**RE: Technical Meeting fee  
Superior Health Linens  
5005 South Packard Avenue  
Cudahy, Wisconsin**

**Subject: Remedial Approach Documentation  
Superior Health Linens  
Cudahy, Wisconsin**

## Request for Technical Assistance

**Subject: Update for Subslab Vapor Testing & Request for Technical Review  
Superior Health Linens – 5005 S. Packard Avenue, Cudahy, WI  
BRRS #02-41-532649 FID #241780880**

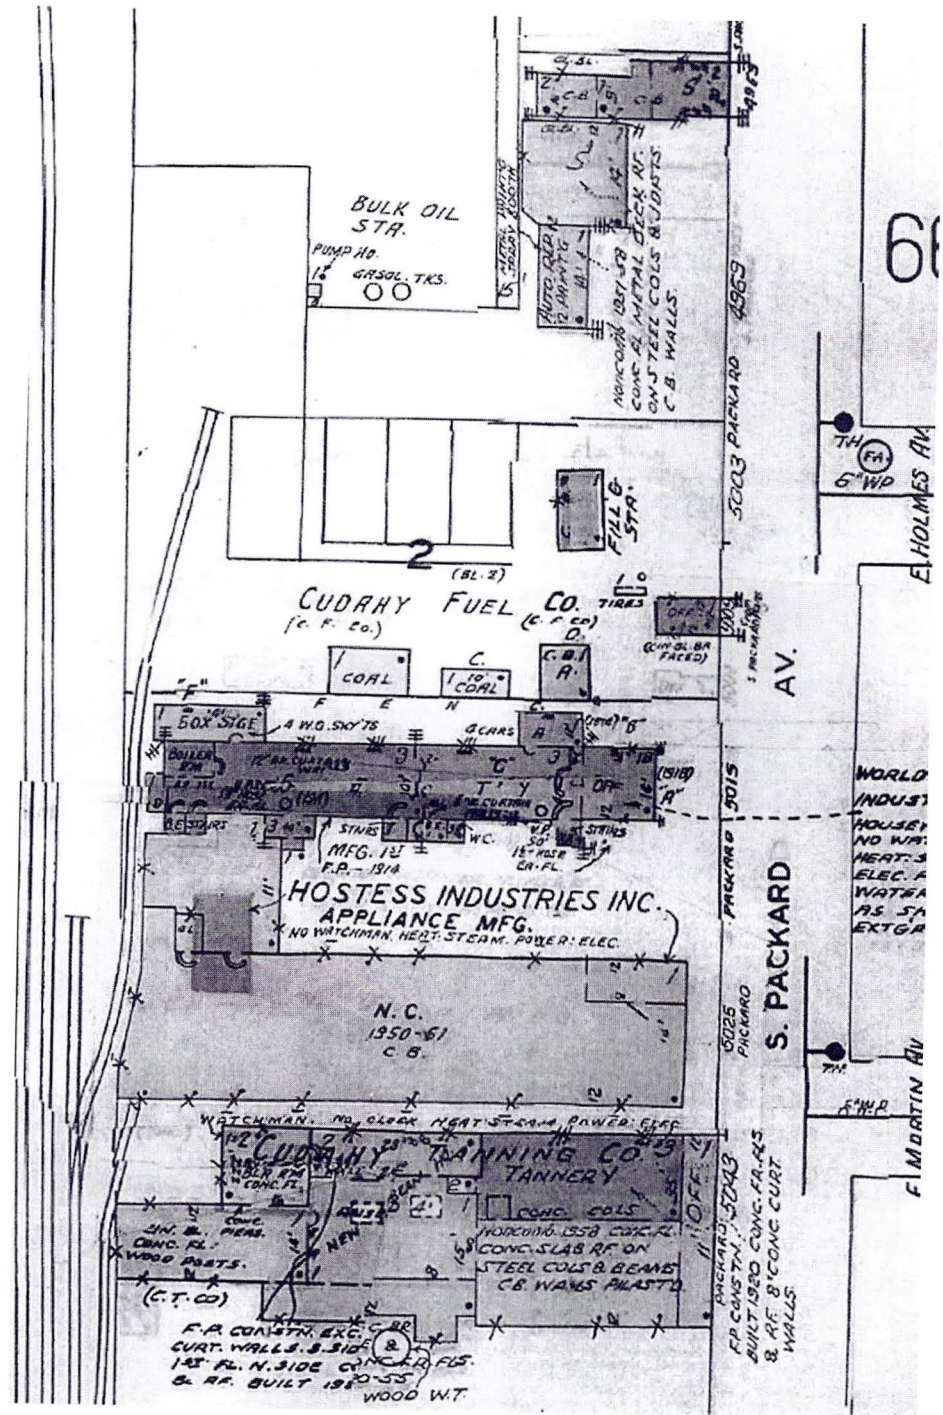
- SSV-2 and SSV-5 were high-purge volume samples.
- Test points indicated that influence area extended to the outside, likely drawing exterior air into the samples.
- Reviewed results with Terry Evanson – request confirmation vapor samples.
- Consultant is proposing installation and operation of 2 radon fans.

*“Assuming a building footprint of 30,000 sq. ft., 6” of sub-slab engineered fill materials with 30 percent porosity equating to 9,000 cu. ft. of air volume. Continuous operation of the blower is expected to evacuate the sub-slab air every 30 min.”*
